December 10, 2019
Medway Planning & Economic Development Board
Meeting

Choate Trail Way Definitive Subdivision
Plan Public Hearing

- Public Hearing Notice dated 11-21-19
- Abutter Notice dated 11-22-19
- Subdivision Application
- Development Impact Report
- Definitive Subdivision Plan dated 11-8-19 by Connorstone Engineering
- Historical Commission Demolition Approval dated 5-2-19
- SAC memo dated 12-3-19 to Town staff requesting review and comments
- PGC plan review comments dated 12-4-19

SHEET: 2 of 6

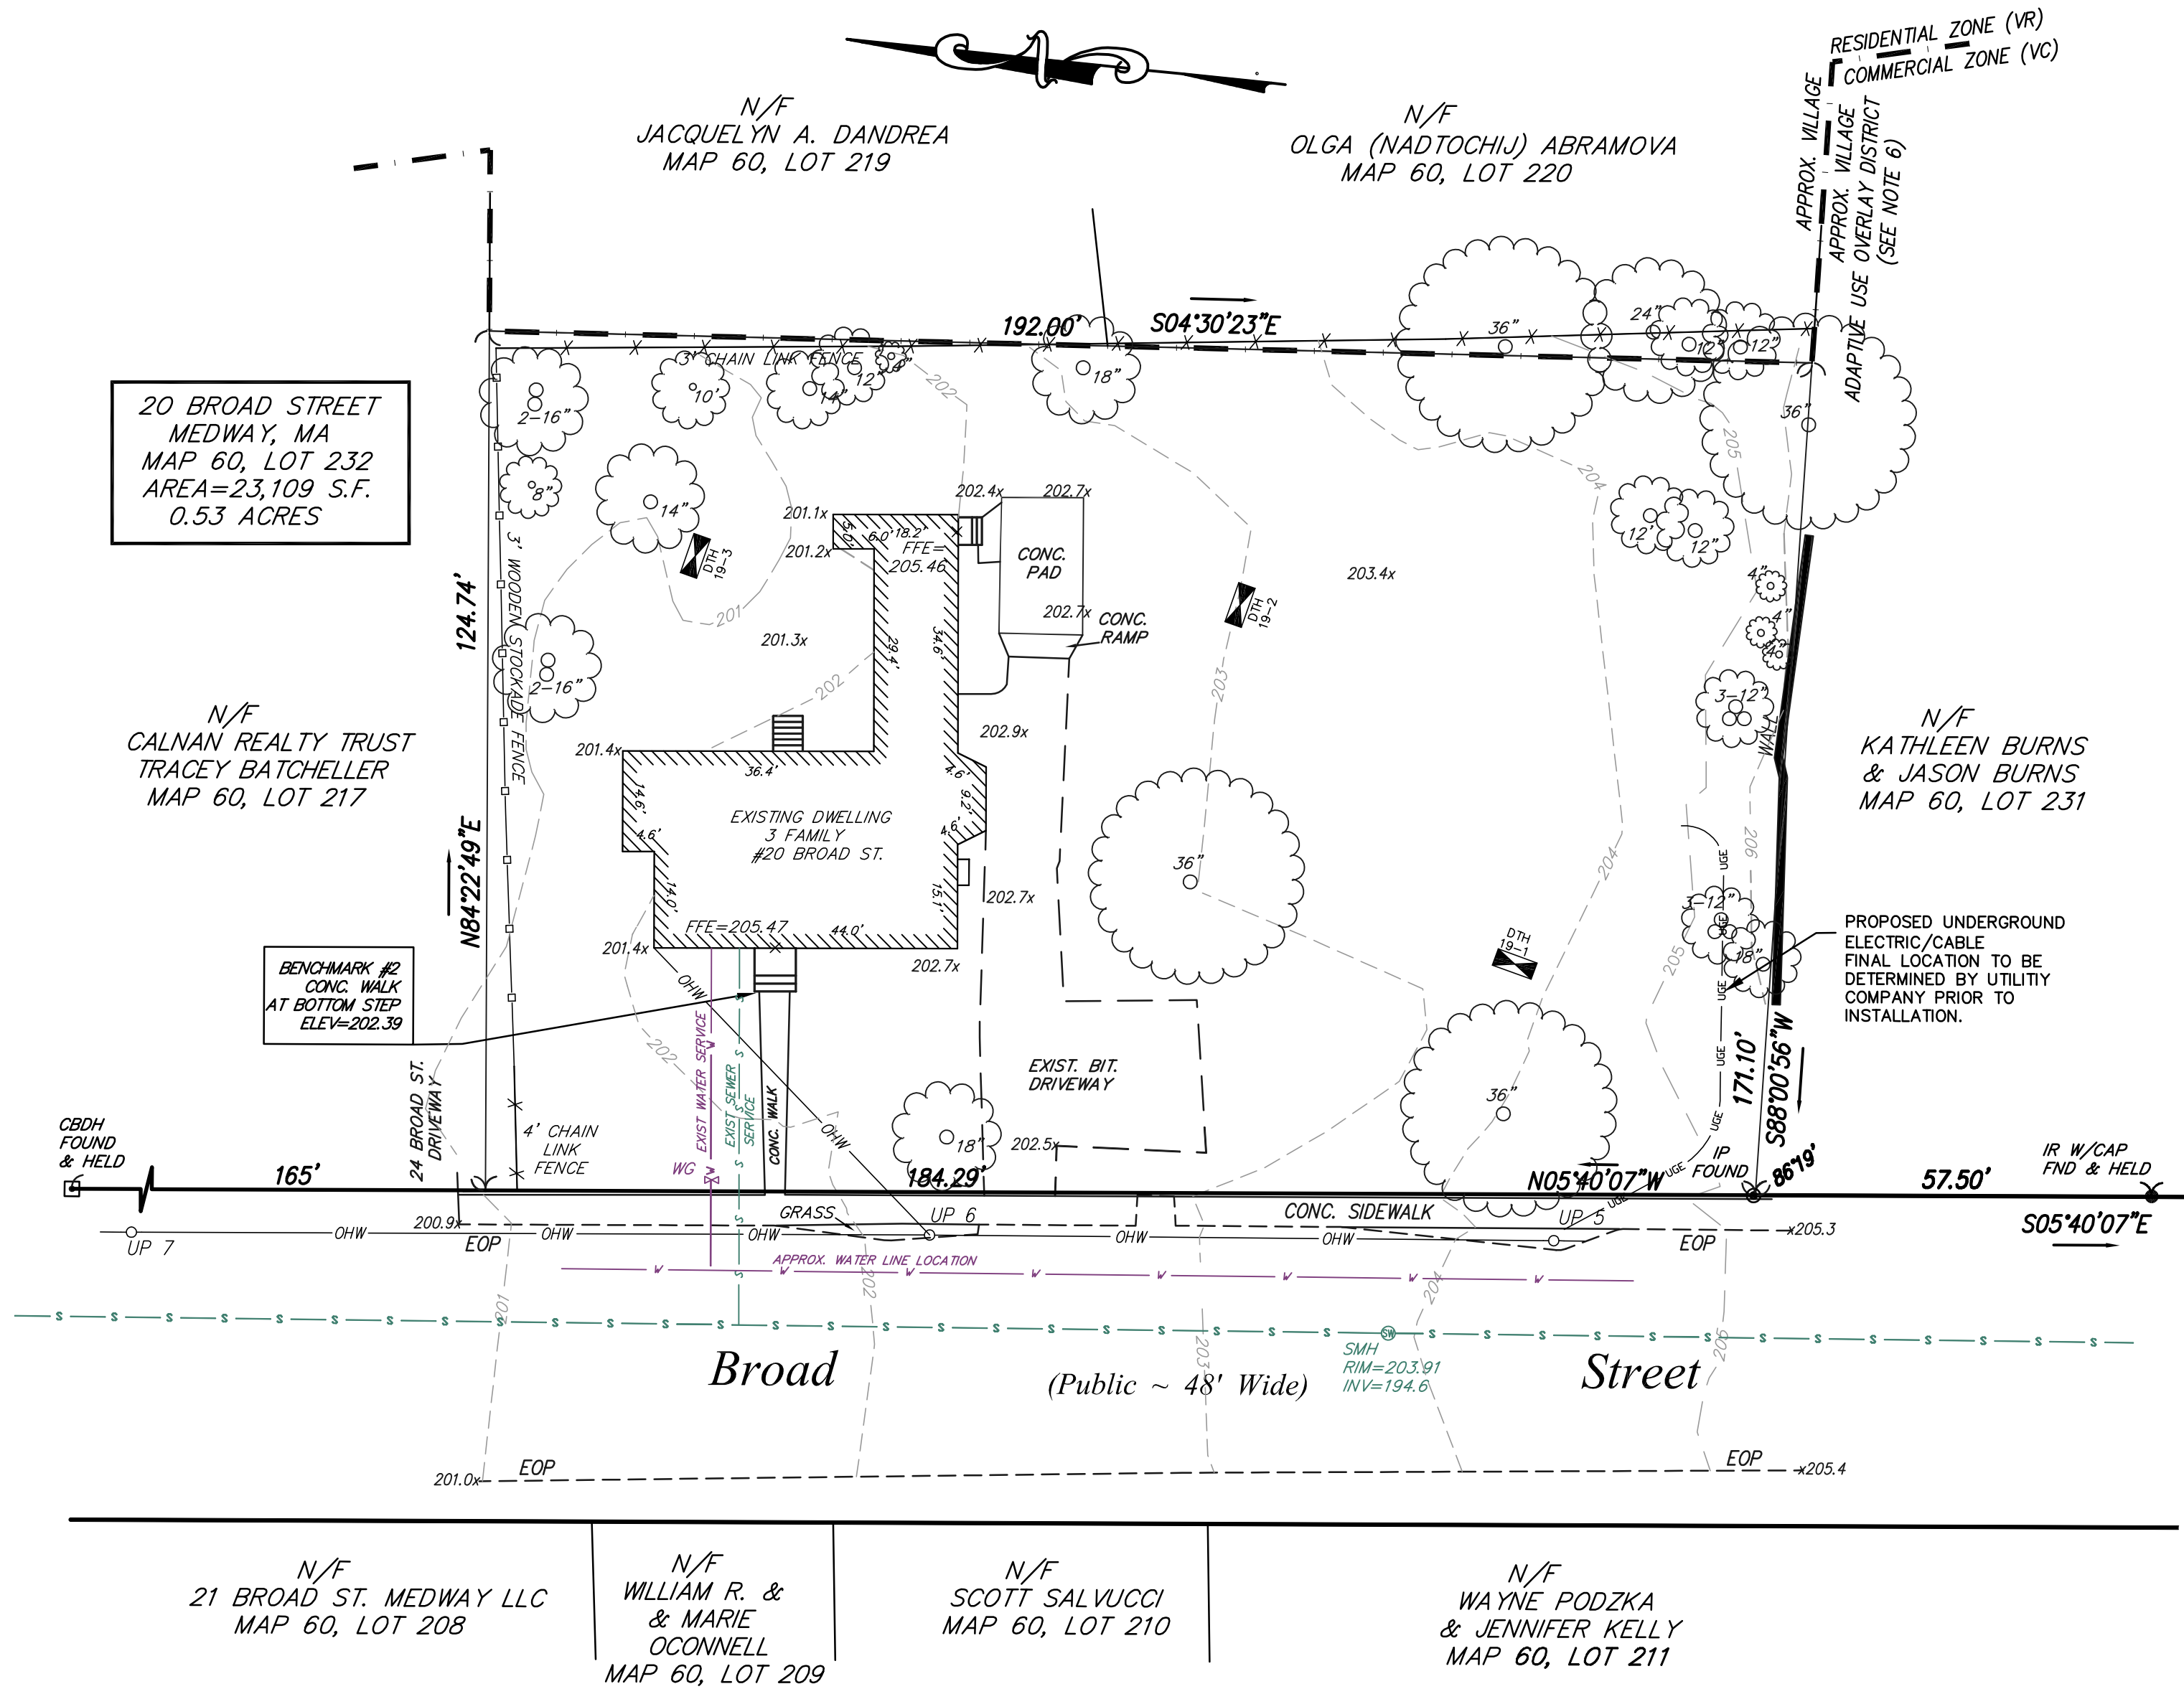
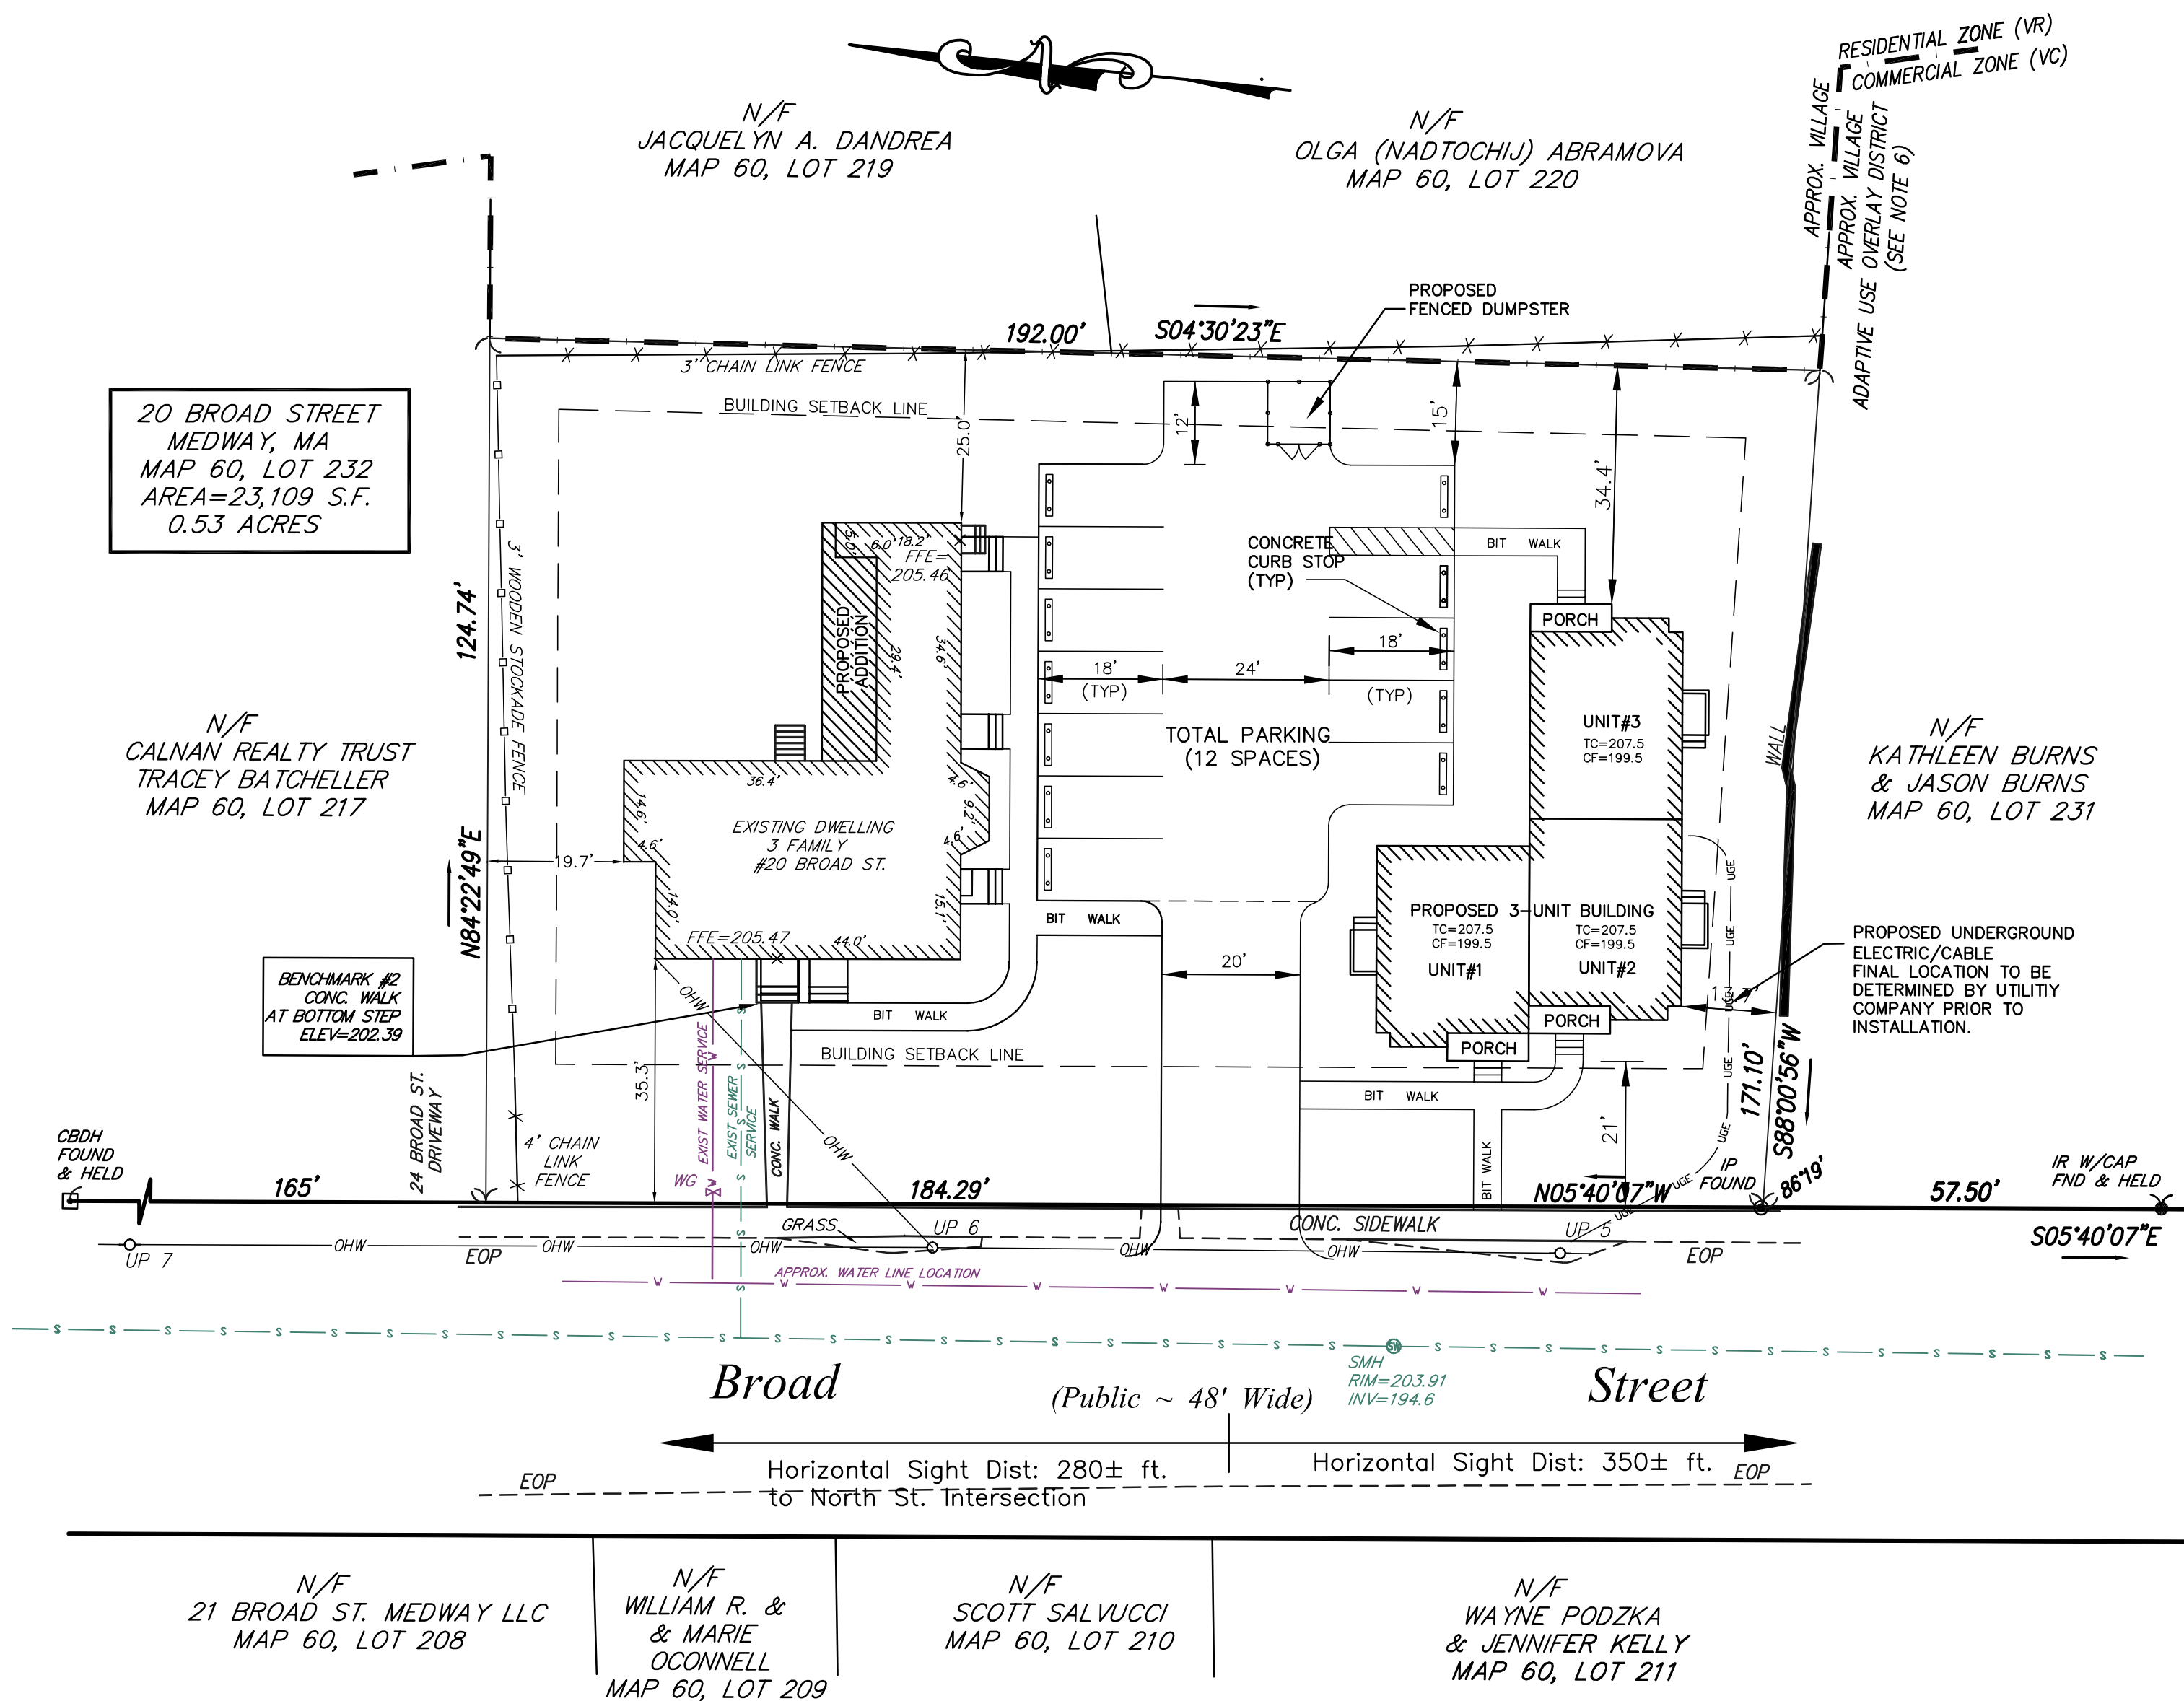
5. The Applicant has not supplied an Existing Landscape Inventory. (Ch. 200 §204-5.C.3)
 - *GLM 11/22/19 Response: Revised, See Sheet 2.*
 - TT 12/4/19 Update: In our opinion, this item has been resolved.

6. Locations of the existing sewer service and existing water main in Broad Street are not provided on the Plans. (Ch. 200 §204-5.C.5)
 - *GLM 11/22/19 Response: Revised, See Sheet 2.*

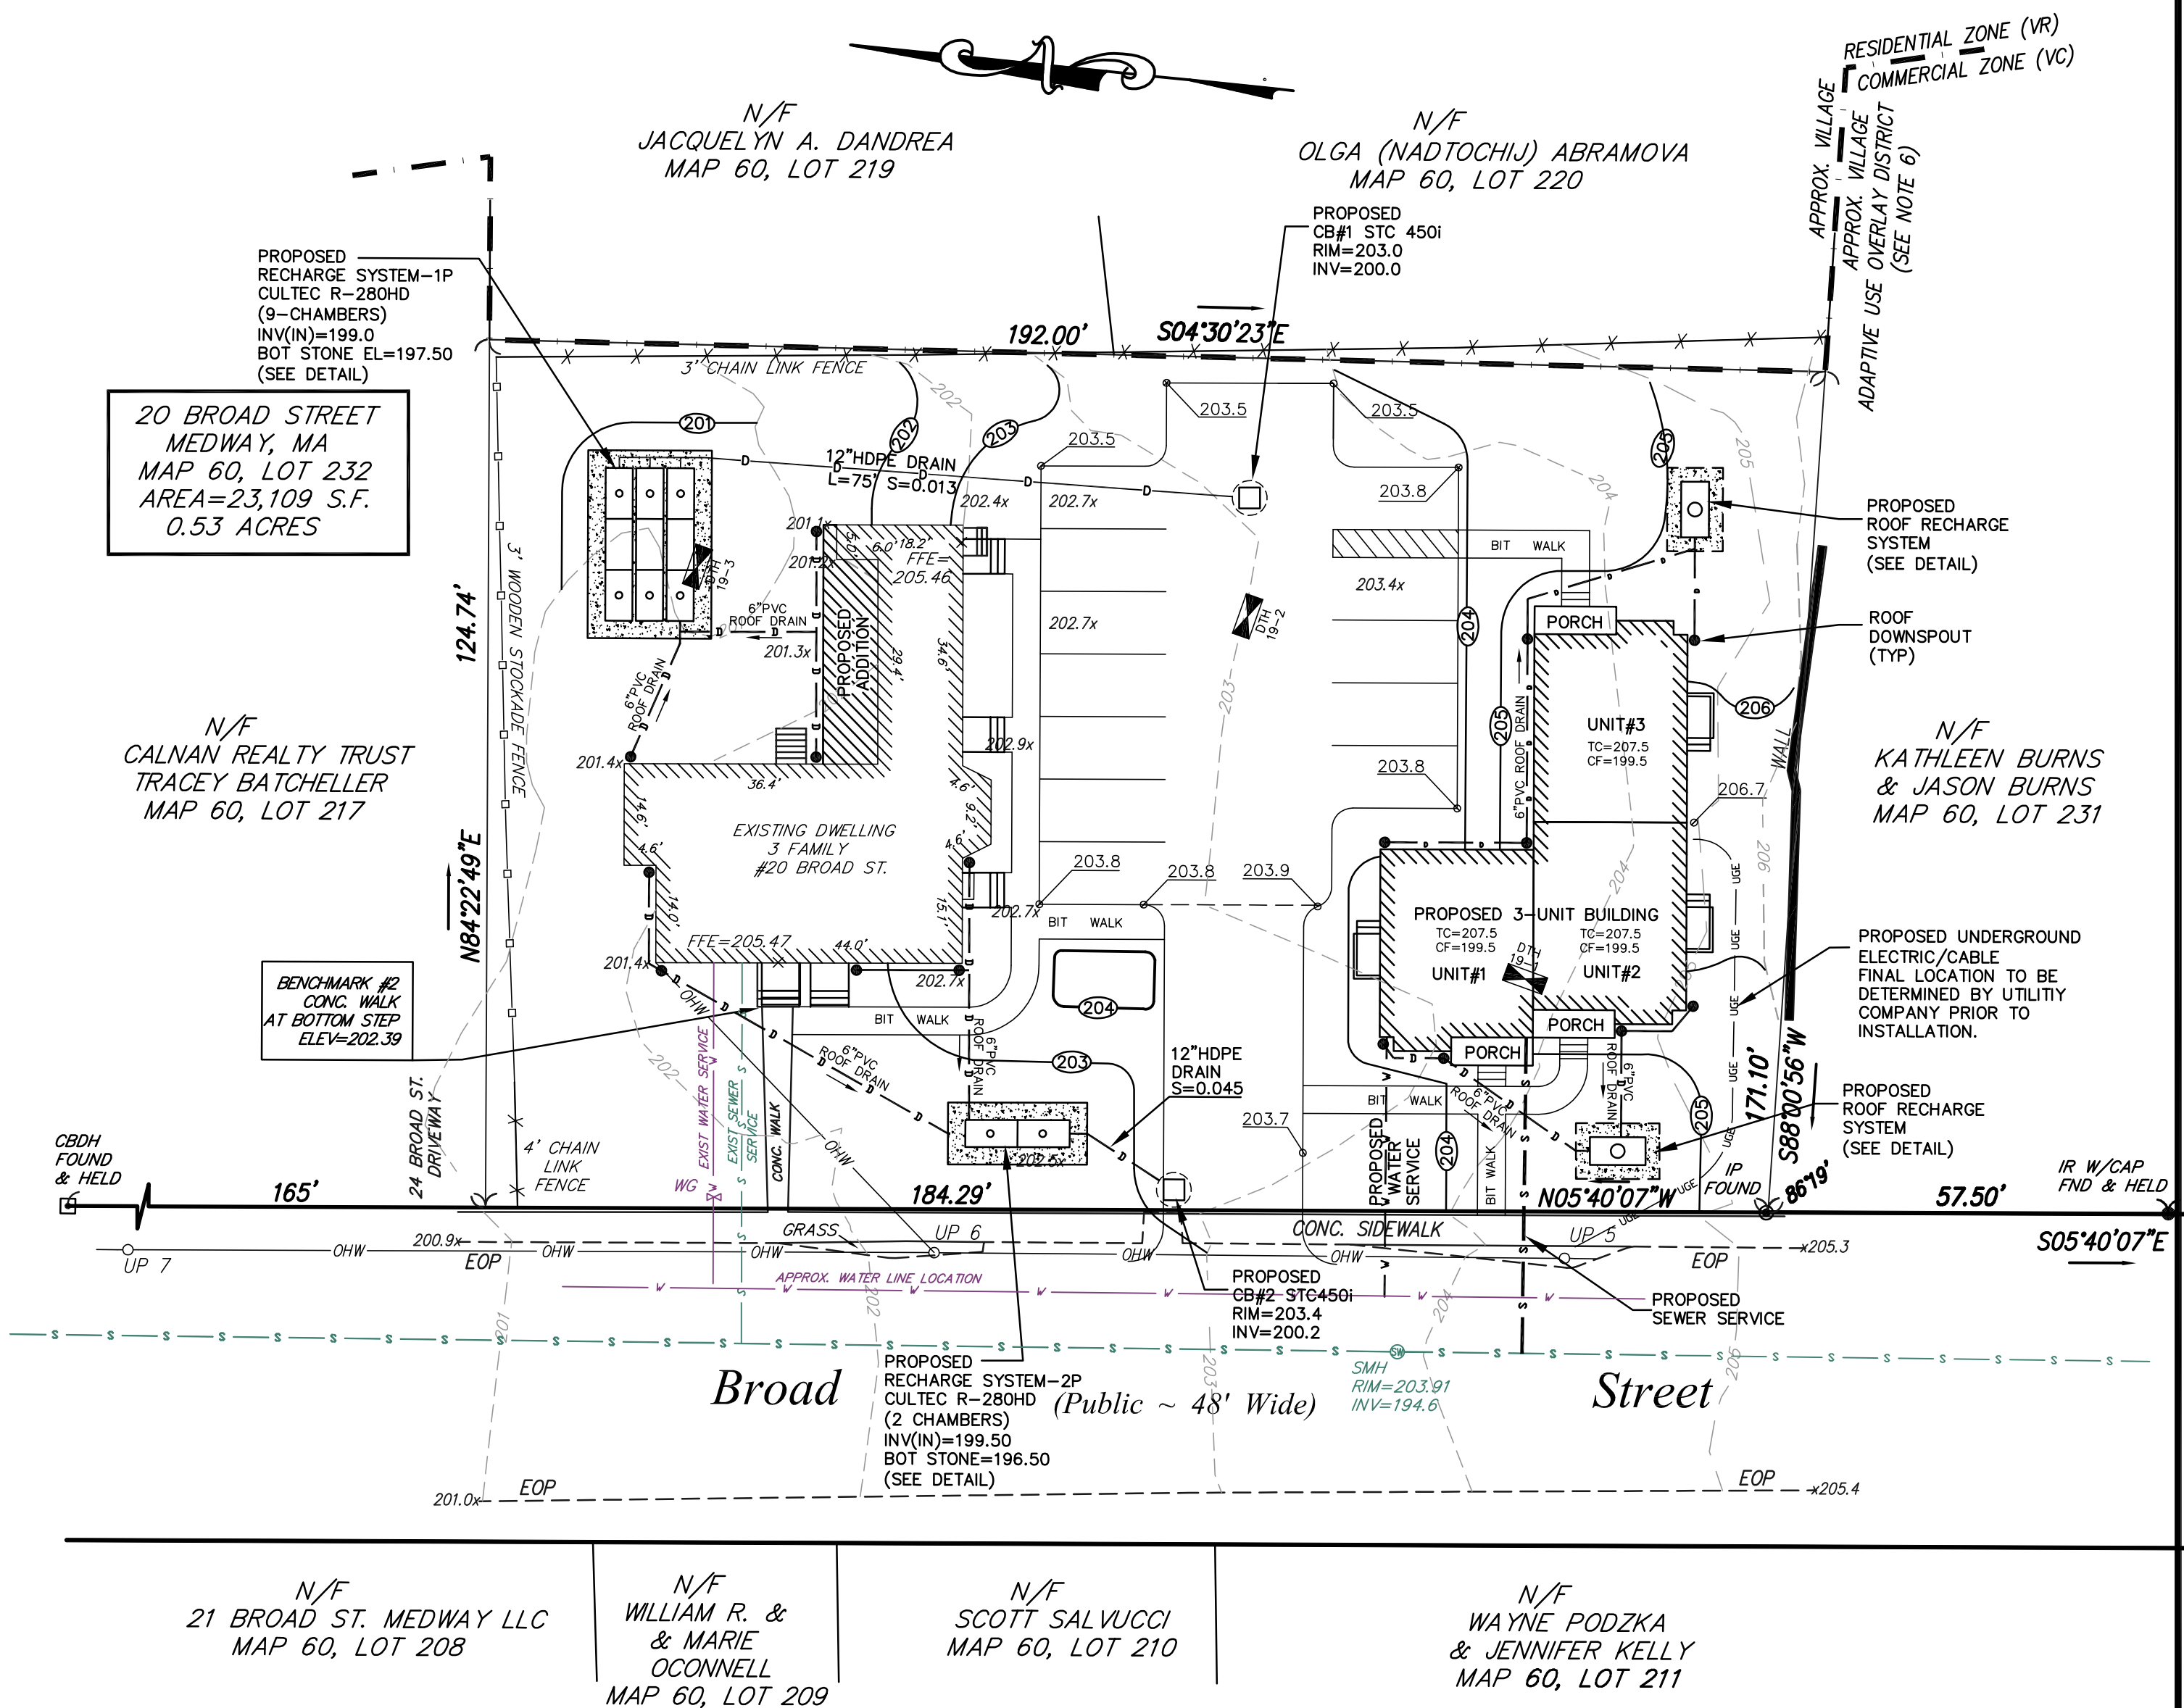
33. Provide walk to parking with hatched no parking lane. See Sheet 3.

34. Revised to add sidewalk to roadway for new building See Sheet 3.

- *GLM 11/22/19 Response: Provide walk to parking with hatched no parking lane. See Sheet 3.*
 - TT 12/4/19 Update: In our opinion, this item has been resolved.

- *GLM 11/22/19 Response: Revised to add sidewalk to roadway for new building. See Sheet 3.*
 - TT 12/4/19 Update: In our opinion, this item has been resolved.
